**RE: Response to Approval with Modifications
French Drain Soil Sampling Investigation Work Plan
Western Refining Southwest LLC, Marathon Gallup Refinery
EPA ID# NMD000333211
HWB-WRG-20-022**

ATTACHMENT A – RESPONSE TO COMMENTS

New Mexico Environment Department (NMED) to Marathon Petroleum Company (MPC) Comment Letter “Approval with Modifications French Drain Soil Sampling Investigation Work Plan” (January 8, 2021)

MARATHON PETROLEUM CORPORATION
GALLUP REFINING DIVISION
FRENCH DRAIN SOIL SAMPLING INVESTIGATION
WORK PLAN

|  1222 Commerce Drive Arame, WY 82070 www.tribhydro.com (P) 307745.7474 (F) 307745.7729 | ATTACHMENT C | | | |

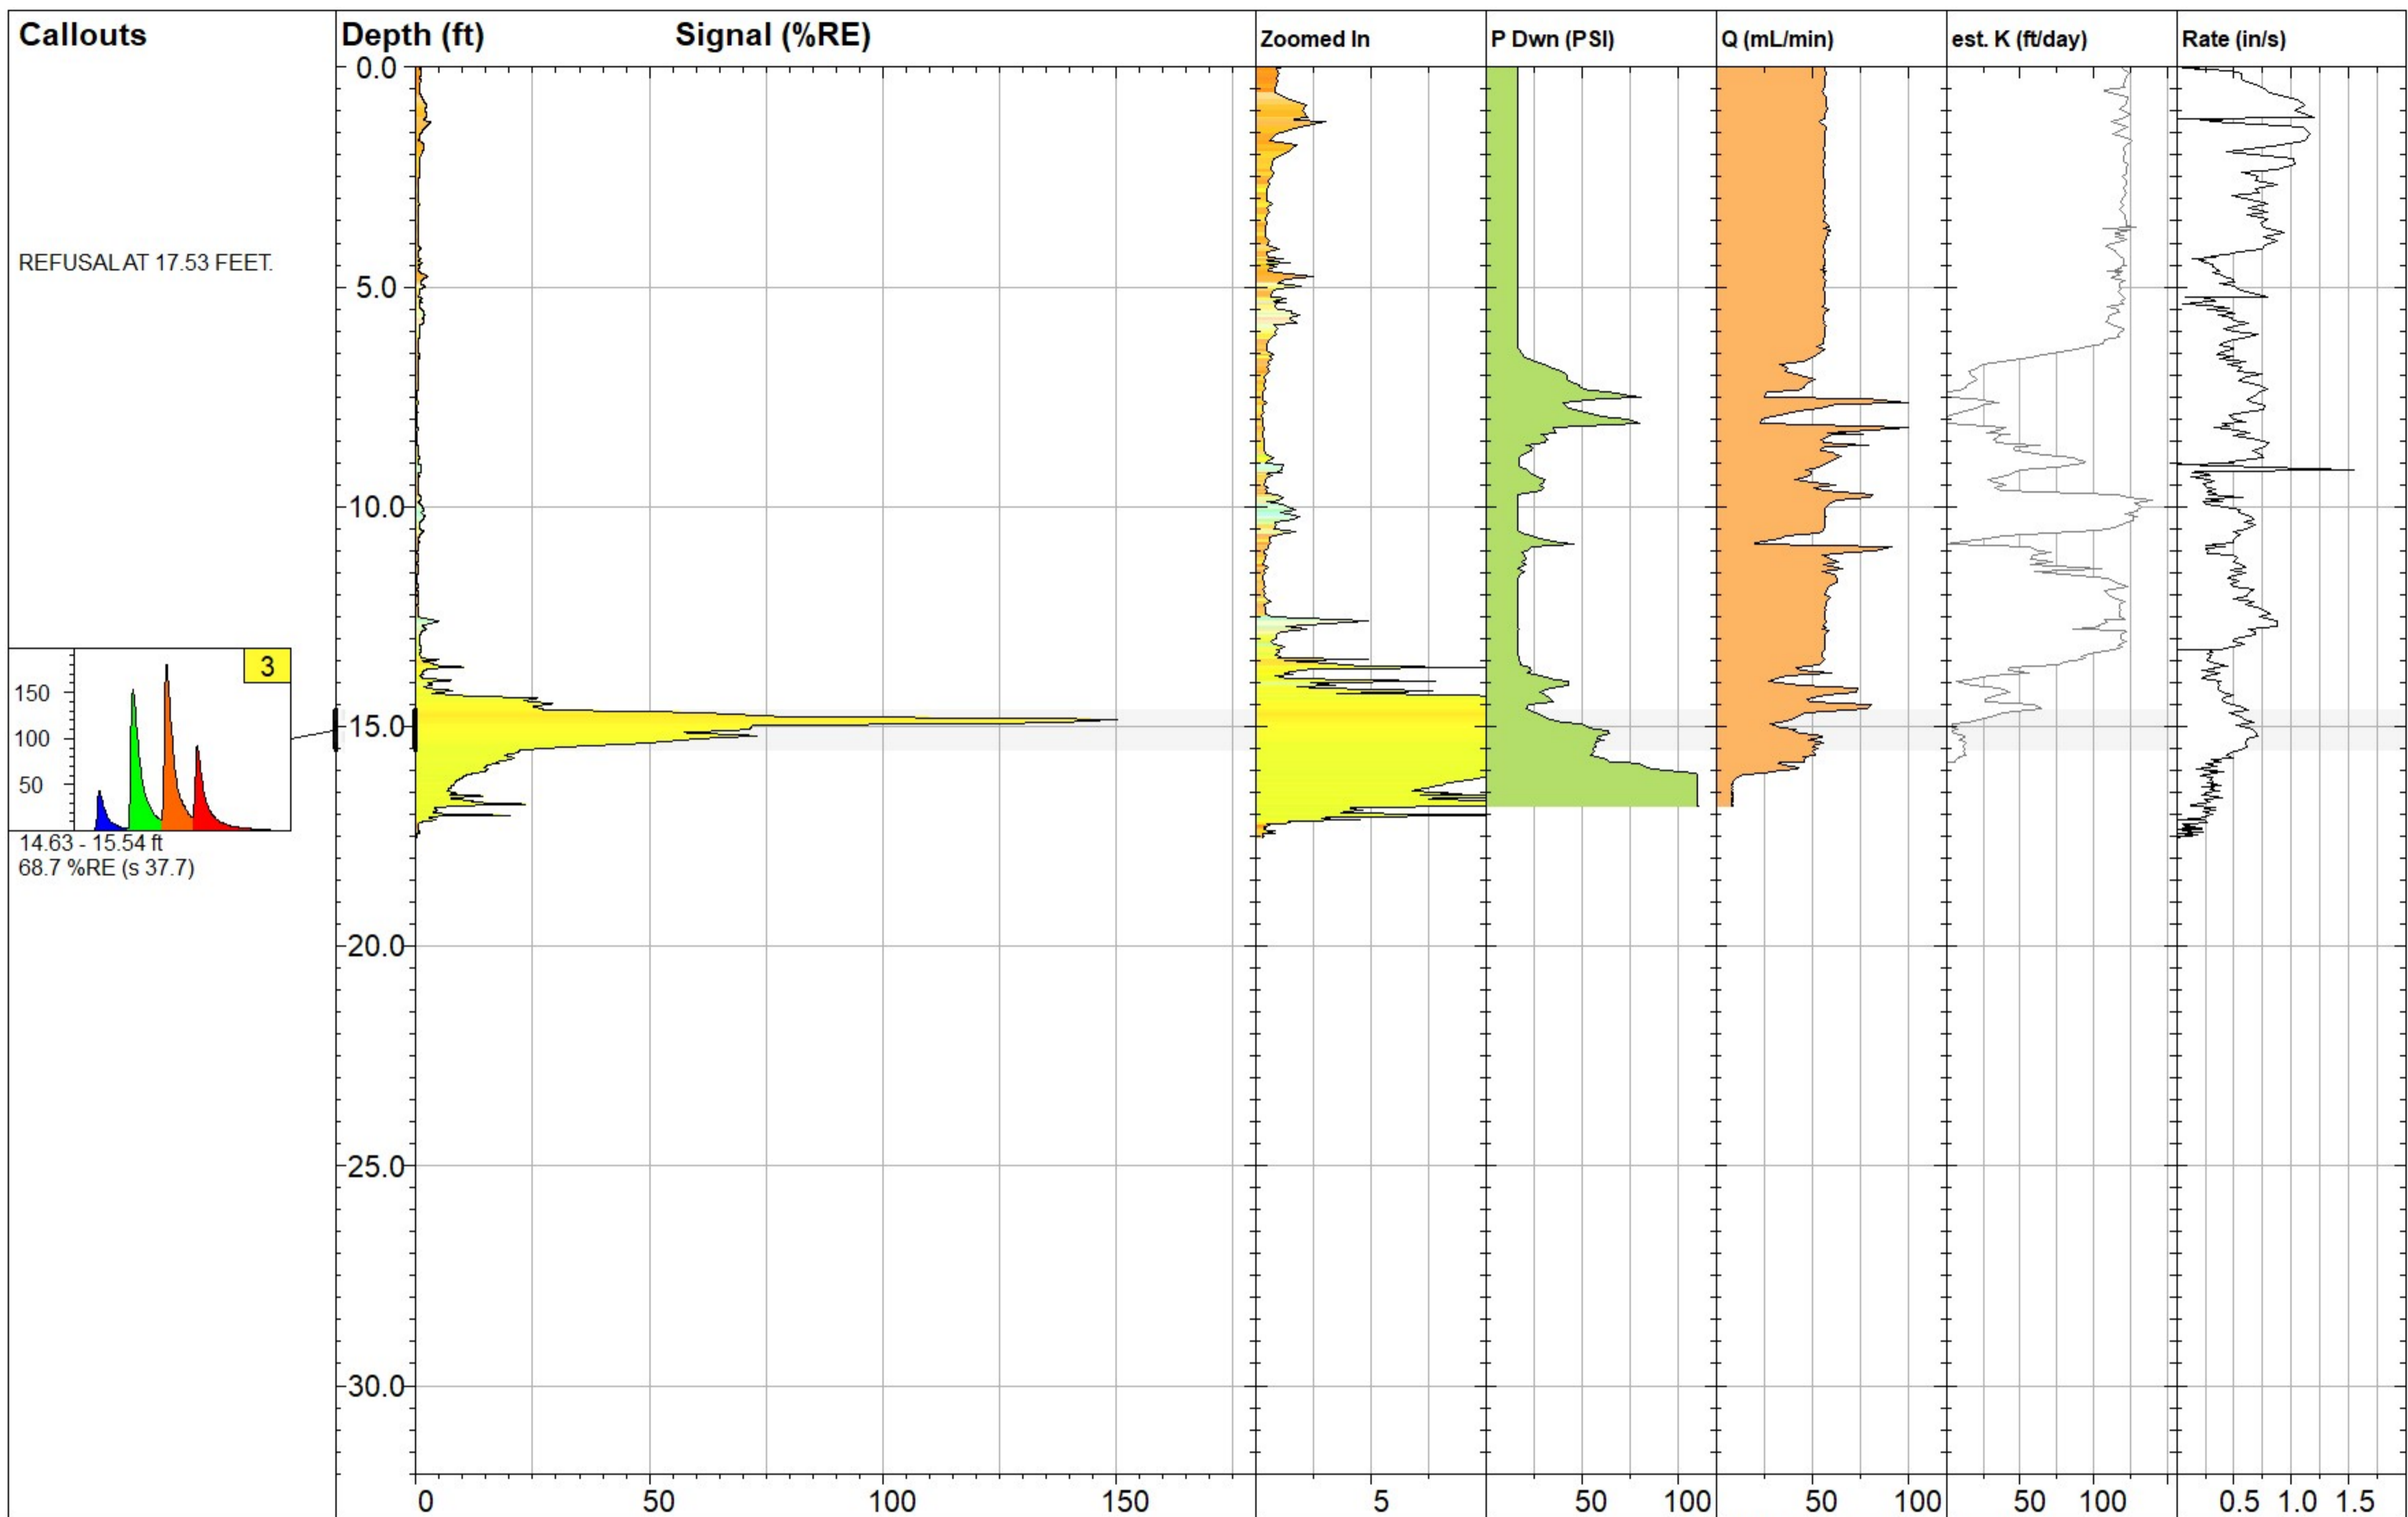
| NMED Comment | MPC Response |
|--|--|
| <p>Appendix A, <i>Well Logs</i>, does not include a boring log for SB-FD-1. In addition, Figure 3 does not depict any proposed borings north of STP-1 to investigate presence or absence of contamination associated with the French Drain release. Provide a boring log for SB-FD-1 and discuss whether (1) hydrocarbons were detected at location SB-FD-1 and (2) soil investigation is warranted north of STP-1 in the response letter.</p> | <p>2018 the drilling rig was set up on location SB-FD-1. Sample collection was accomplished using the HSA drilling method and split spoon samplers. No discrete soil samples were retained for laboratory analysis since the field screening results did not indicate potential contamination and the focus of this effort was the identification of SPH. The lithology encountered consisted of the following:</p> <ul style="list-style-type: none"> ▪ The 0 to 10 foot interval was not logged due to use of hydro excavation to clear the location; ▪ Silty Clay: 10 - 14 feet below ground level (bgl) (low plasticity, very stiff, dry to damp, reddish brown, calcareous at base no odor); ▪ Silty Clay: 14 - 24 feet bgl (low plasticity, firm/crumblly, damp, light reddish brown, very calcareous 15.75 — 16.0 feet, no odor, increase in silt lower 2 feet); ▪ Silty Clay: 24 - 38 feet bgl (low plasticity, very stiff, dry to damp, reddish brown with greenish gray color from 24 to 26 feet bgl, thin 1” sandstone lens at 25.75 feet and calcareous 34 to 36 feet bgl, no odor); <p>The boring was left open for two days but did not produce water and was plugged on March 9, 2018.”</p> <p>Figure 3, <i>Proposed Soil Boring Location</i>, does not depict any proposed soil borings north of STP-1 because the area was included in Sitewide LIF Investigation, completed during the week of May 10, 2021. The Sitewide LIF location figure is provided in Attachment C.</p> |

| NMED Comment | MPC Response |
|---|--|
| <p>Comment 7:</p> <p>In the Investigation Methods Section, page 7, the Permittee states, “[t]he proposed sampling locations are shown on Figure 3. The proposed locations include six boreholes around the STP-1 French Drain area.” The proposed sampling locations shown on Figure 3 are anticipated to delineate the extent of hydrocarbon contamination detected at BH-1, BH-2, and Excavation #9; however, do not appear adequate to delineate the extent of hydrocarbon contamination detected at BH-3 and potential hydrocarbon contamination northwest of the French Drain. Two additional soil borings as shown in the figure below must be proposed in the revised Work Plan. The suggested boring locations below may be adjusted based on the accessibility of the site. Revise the figure accordingly.</p> <p><u>[Suggested additional boring locations were provided by NMED on a figure included with the comment.]</u></p> | <p>Response 7:</p> <p>Figure 3, <i>Proposed Soil Boring Location</i>, does not depict any proposed soil borings in the vicinity of BH-3 and potential impacts north west of the French Drain because the area was included in Sitewide LIF Investigation, completed during the week of May 10, 2021. The Sitewide LIF location figure is provided in Attachment C. The Sitewide LIF investigation provided adequate coverage of the area</p> |
